Colorado Department
of Public Health
and Environment

Re: Colorado Radioactive Materials License # 317-02, Response to NRC Geologists
Report Regarding Groundwater at the Hecla-Durita Site

TECHNICAL REVIEW OF HYDROGEOLOGIC CONDITIONS AT THE DURITA SITE, MONTROSE COUNTY, COLORADO

Photo 1 – Outcrop of Mancos shale in an arroyo east of Durita site showing weathering to soil consistency and absence of vertical fractures.

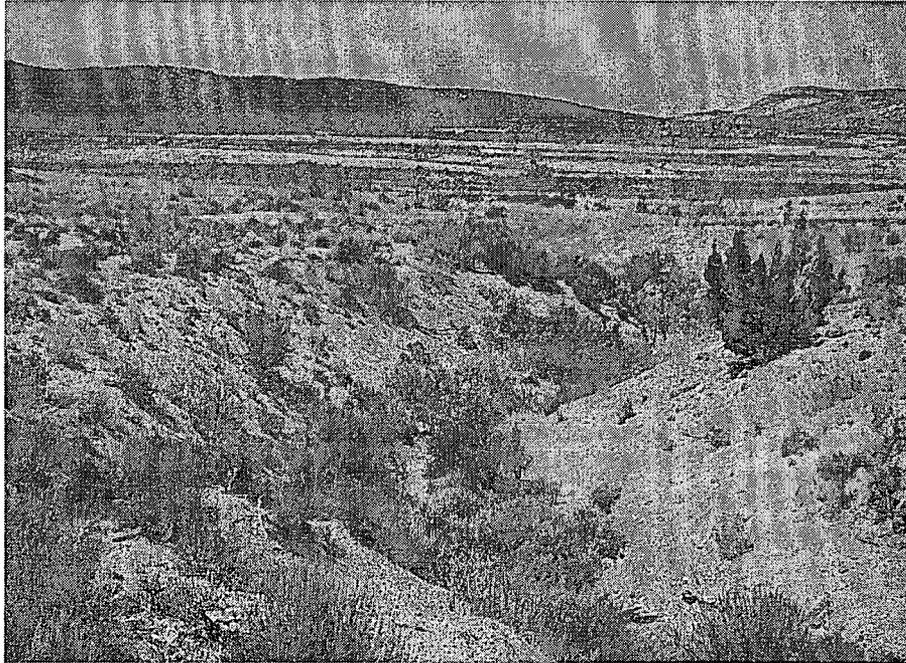
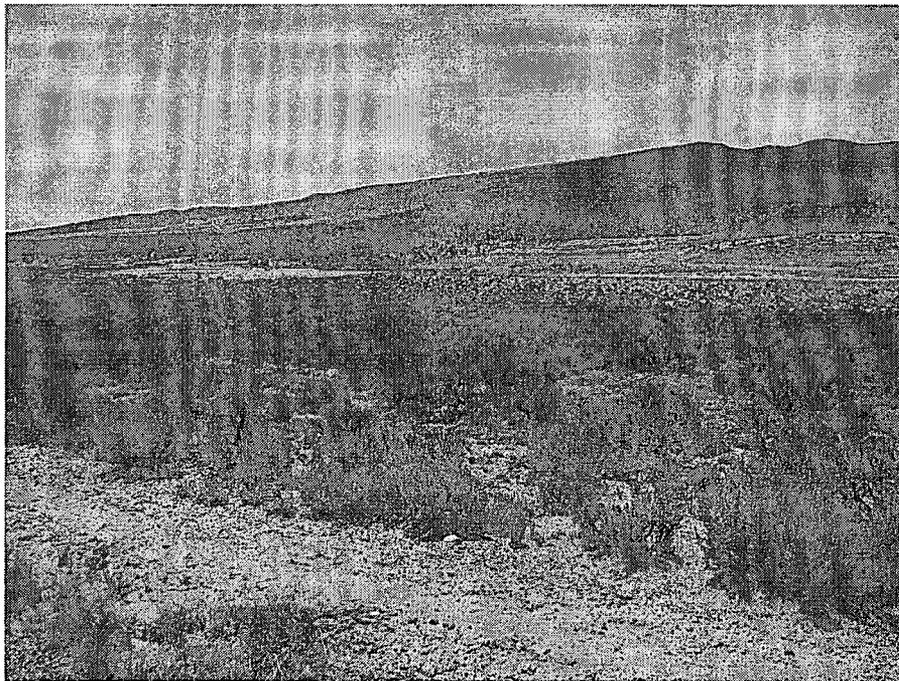
There is substantial information to show that these preferential pathways are not likely to exist. The NRC raised a concern that these pathways are possible based on their field observations during a site visit. The NRC made field observations of vertical fractures in the Km exposures of the cut slope on the west side of Mancos Hill and in the cut bank of Dry Creek northwest of the site. On page 10 and 11, section 4.2.4 of the report on the NRC site visit, the NRC states "Near surface bedrock was fractured..." "Thus, there is uncertainty in the ...hydrologic properties...of the Mancos". NRC staff noted heavy vertical fracturing in outcrops of the Km, leading them to speculate that systematic and vertically persistent pathways for rapid infiltration through the Km to groundwater exist. This scenario does not take into account the physical properties of the Km.

The Mancos is widely spread across the Southwest and displays similar structural and textural features in all its locations. The Mancos is known for its shrink/swell behavior and low slaking durability. Smectitic clays in the Km have large shrink/swell potential, causing them to expand with more moisture and to shrink (crack) as they dry. Incipient fractures will open upon exposure to air and cyclic freeze/thaw but remain closed below the zone of weathering and moisture variation. With its relatively high amount of smectitic clay, the Mancos is hygroscopic enough to take up free moisture into the clay lattice structure, causing it to develop swell pressures that close the fractures when continuously moist. This phenomenon is commonly observed when the Mancos is excavated to depths that expose the fresh shale; incipient fractures open as the shale dries and the smectitic clays shrink.

Therefore, these open fractures are surficial phenomena and are not persistent with depth. The Mancos Hill cut was made during site closure, and the Dry Creek cut bank is an actively eroding exposure that continues to slough to fresh surfaces; neither exposure is old enough to have weathered to soil. With time the shale slakes to finer fragments and finally to a clay soil. As the exposed Km surfaces weather, the shale breaks down to a clay soil consistency; this weathering is evident in a number of relatively recent Km cuts around the site that are only a few decades old (see photos 1 and 2). No open fractures are preserved in these surfaces.
